**Case File Number: ZP160061**

**May 3, 2017**

<b>Location:</b>	<b>325-22<sup>nd</sup> Street (APNs 008 065300800, -0900, -1501).</b>
<b>Proposal:</b>	Highrise commercial and office building
<b>Applicant:</b>	CIM Group, Sean Buran: p: (323) 860-1811
<b>Owner:</b>	CIM Group
<b>Planning Permits Required:</b>	Design Review, Major CUP, Minor Variance.
<b>General Plan:</b>	Central Business District
<b>Zoning:</b>	CBD-C (Central Business District Commercial Zone)
<b>Environmental Determination:</b>	To Be Determines
<b>Historic Status:</b>	None (surface parking lot).
<b>Service Delivery District:</b>	Metro
<b>City Council District:</b>	3 – Lynette Gibson McElhaney
<b>Action to be Taken:</b>	Conduct design review
<b>Finality of Decision:</b>	NA (Design review, only; No action will be taken at this meeting)
<b>For further information:</b>	Contact case planner <b>Catherine Payne</b> at <b>510-238-6168</b> or by e-mail at <b>cpayne@oaklandnet.com</b>

# CITY OF OAKLAND PLANNING COMMISSION

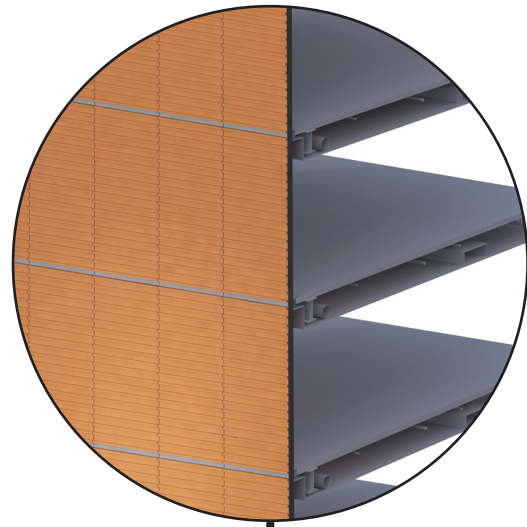
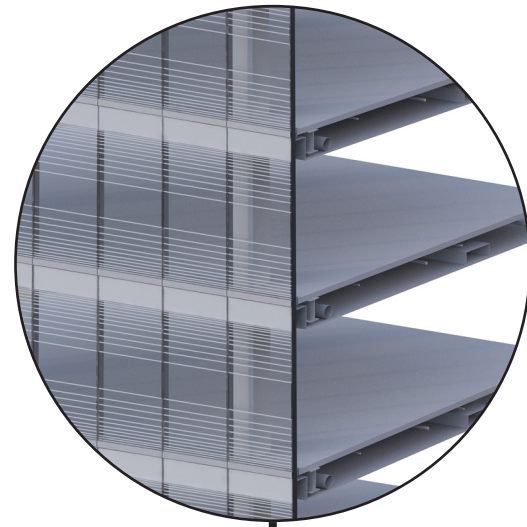
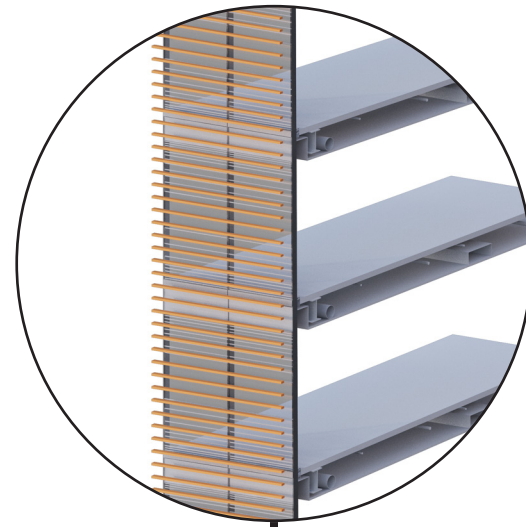
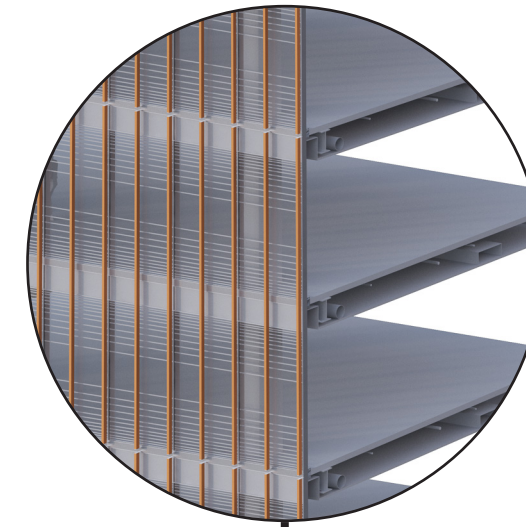
- Terracotta: The applicant should provide samples of the terracotta and explore options for other opaque applied materials. Staff is particularly concerned about the extent of the terracotta application on the smallest of the three masses. This mass has few and fairly small openings above the ground floor and appears heavy and monolithic. The applicant should explore possibilities for more penetrations, and more transparent materials.
